# Access Compliance Report

## Public Rights-of-Way

### (Pedestrian Signals)

Intersection ID: N/A	Main Street:	Cross Street: N/A	Location: N/A
ADA ID: 7238574D3ED7	Signal Type: One Push Button-Non APS	Overall Compliance: No	Severity Score: BTN 1: N/A BTN 2: N/A No BTN: N/A
Codes/Mitigation Info/Possible Solution		Field Measurements/Component Compliance

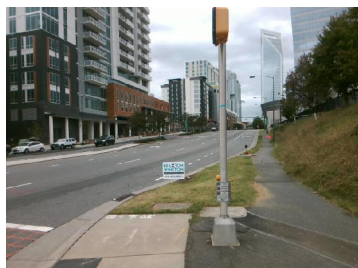
PROW/ADA: R209.1, TMUTCD 4e.08, R404.2, R406.2

Yes	B 1 Clear Xing Direction?	ClearlyMarked	N/A	B 2 Clear Xing Direction?	N/A
	B 1 Crossing Direction	To SW		B 2 Crossing Direction	N/A
Yes	B 1 DistanceTo XWalk (in)	0.0	N/A	B 2 DistanceTo XWalk (in)	N/A
No	B 1 DistanceTo Curb (in)	99.0	N/A	B 2 DistanceTo Curb (in)	N/A
Yes	B 1 Diameter (in)	2.0	N/A	B 2 Diameter (in)	N/A

Possible Solutions: Replace Signal Push Button With APS Button on New Post. Remove & Relocate Sign.
